| TYPE | YEAR | PROJECT NO. | SHEET NO. |
|---|---|---|---|
| CONST. | 2017 | HSIP-106(33) | 10 |

STATE OF TENNESSEE
DEPARTMENT OF TRANSPORTATION

# CULVERT SECTIONS

STA. 116+02.59
TO
STA. 116+02.59

116+02.59
SR-106

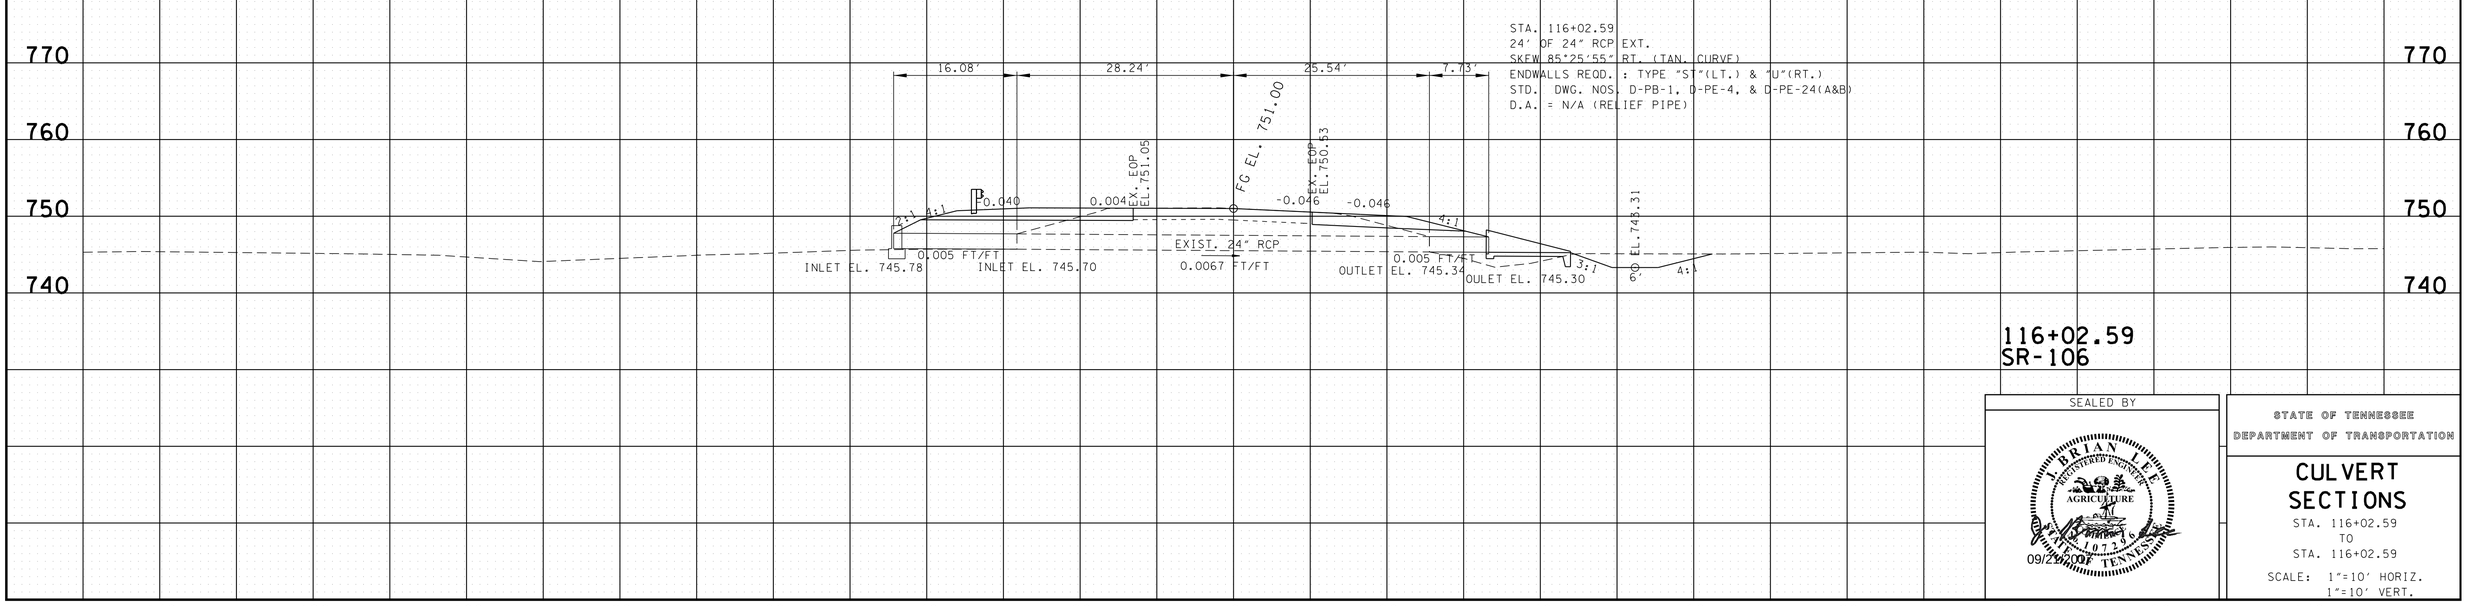
REV. 12-08-16: ADJUSTED PIPE STA. 116+02.59 PER REMOVING GUARDRAIL PAD AND CHANGING SLOPE FROM 2:1 TO 4:1.
